Burrendong Wind Farm

Submissions Report

Ark Energy

Figure 4-1: Impacts to Box-Gum Woodland from Project inception through to the current Development Footprint

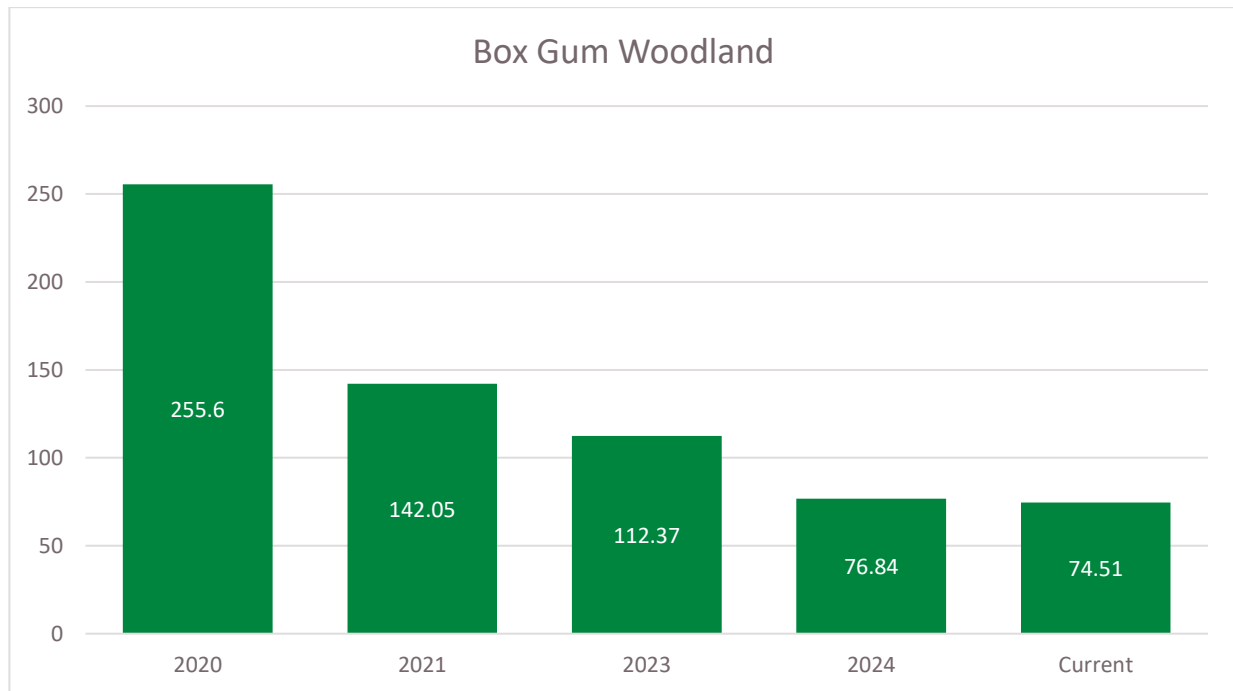
Impacts to Box Gum Woodland are deemed to be an SII, Section 8.1 of the revised BDAR (ELA 2026b) provides an updated assessment for Box-Gum Woodland against the assessment criteria for SII entities. A hierarchy was followed to minimise impacts by firstly avoiding those areas that were in woodland condition, followed by those areas with a diverse ground layer in the Derived Native Grassland (DNG) areas, especially areas that conformed to the EPBC Act listed community; through to degraded grasslands with a priority of locating impacts within poor quality areas. DNG refers to areas that result from historical clearing and current agricultural land use. Of the 76.2 ha of Box Gum Woodland that remains present within the Development Footprint, 90% is DNG.

As shown in Figure 4-1 and described further within the revised BDAR (ELA 2026b), impacts to the SAI Box-Gum Woodland have decreased from Project inception in 2020 (255.6 ha) to the Development Footprint (112.37 ha) presented within the EIS (ELA 2023a) and then finally to the current amended Development Footprint (74.51 ha).

Figure 4-2: Inaccessible areas

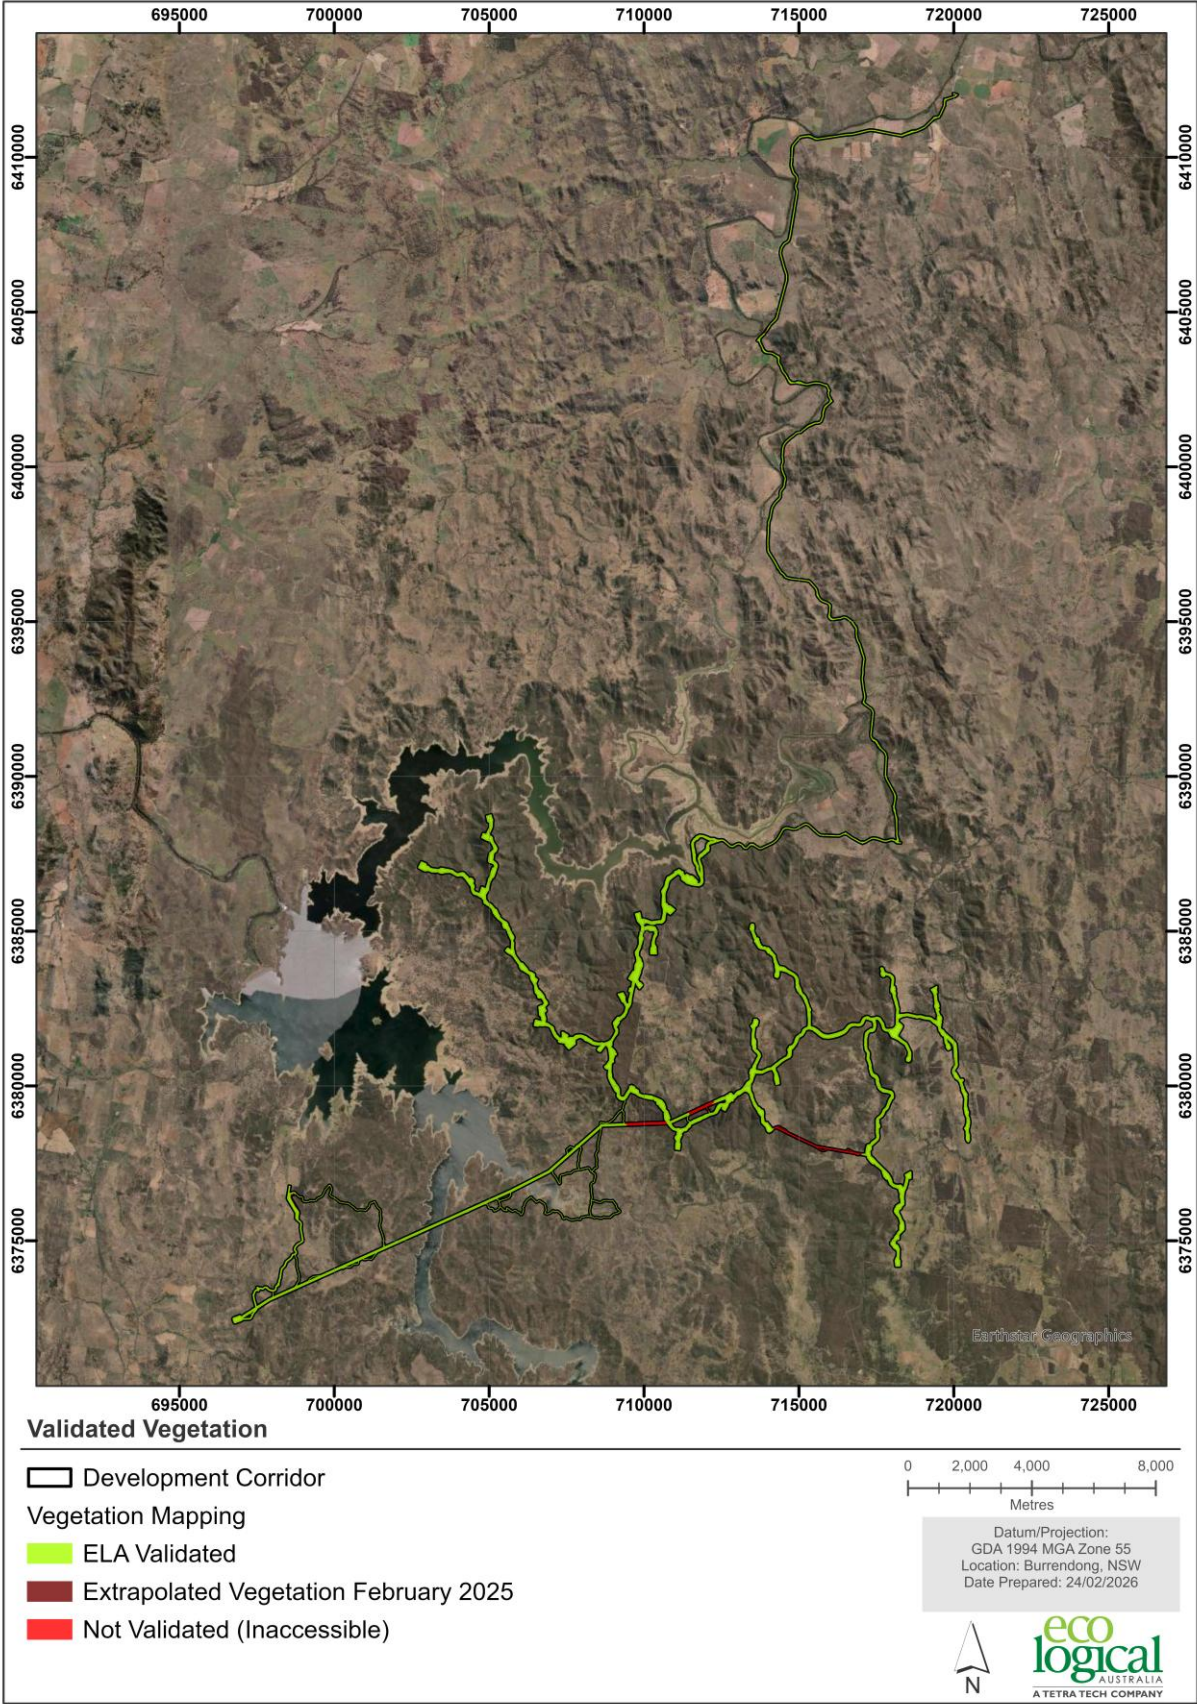
The MNES assessment is not compliant with Commonwealth guidelines and the BDAR does not provide the information required for BCS to complete a Bilateral Assessment.

For areas that were inaccessible for surveys due to slope or safety concerns, assumptions have been made to ensure comprehensive impact assessment and to conservatively account for their potential ecological value. All inaccessible areas associated with a TEC have been assumed to meet the listing criteria for the TEC. Any areas that required additional plots were assumed to be a benchmark condition, representing the highest ecological quality and habitat value for the associated PCTs (Table 4-8 and Figure 4-2). Inaccessible areas are assumed to provide habitat for species credit species and offset credits have been calculated for these species by making these conservative assumptions, the Project has estimated the maximum potential impacts to biodiversity.

Figure 4-11: Wire Frame Diagram prepared from U8-1: 2022 Superseded layout (Moir Studio 2026)

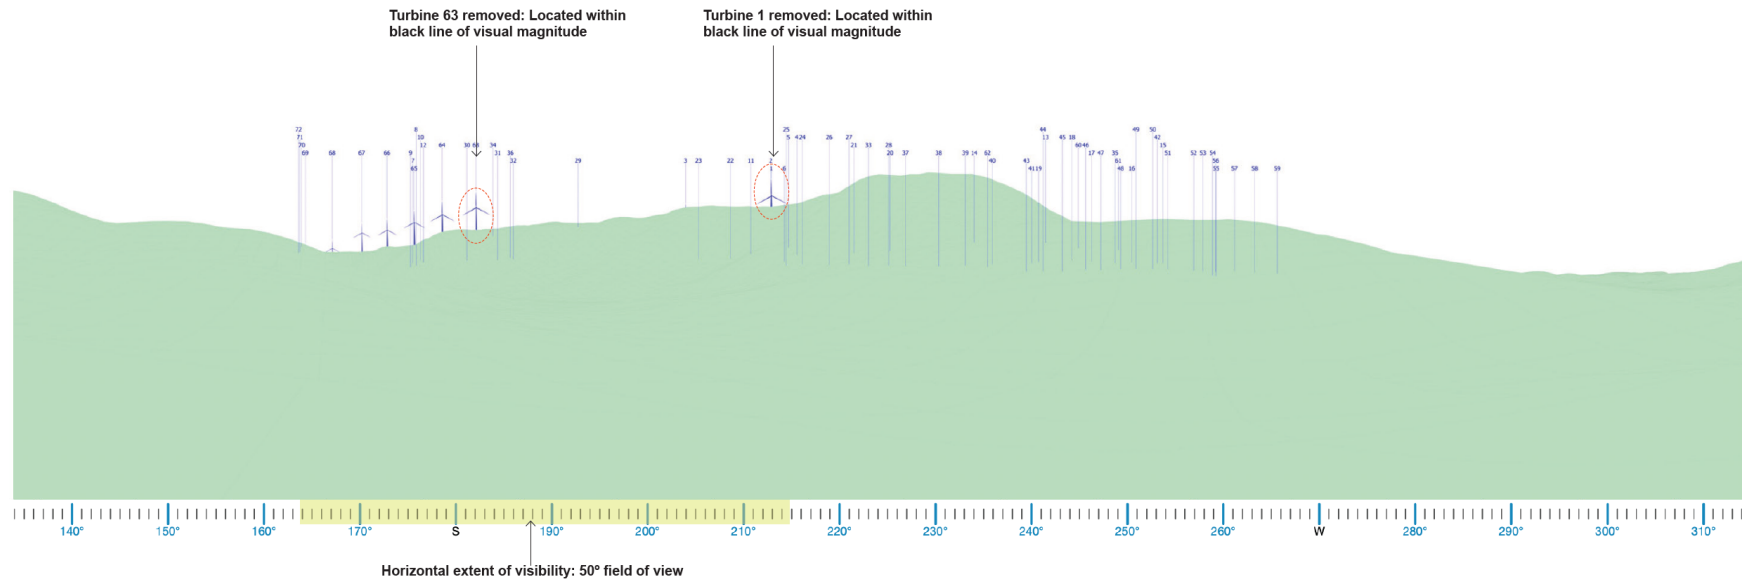
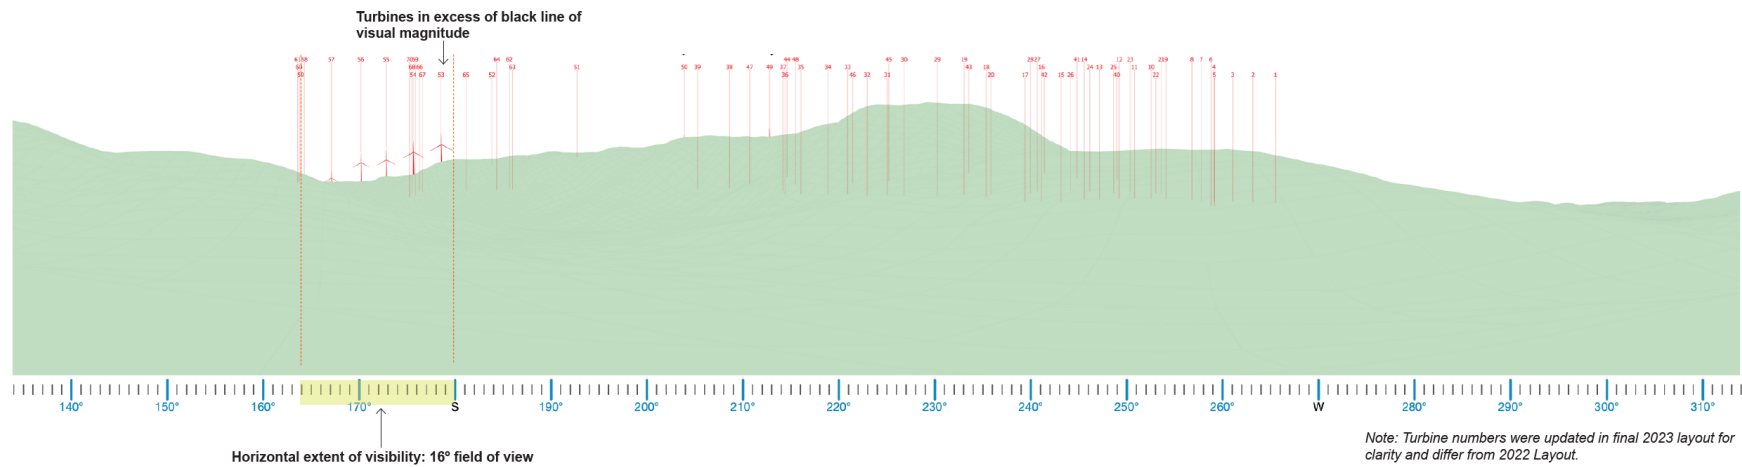
VISUAL IMPACTS ASSOCIATED WITH U8-1 (167 Rockford Lane, Yarrabin)

Figure 4-11 provides an overview of the design iterations undertaken by the Proponent with the advice from MLA to reduce visual impacts from Dwelling U8-1 showing a further reduction in the visual impact of the Project by removing WTG 1 and 63.
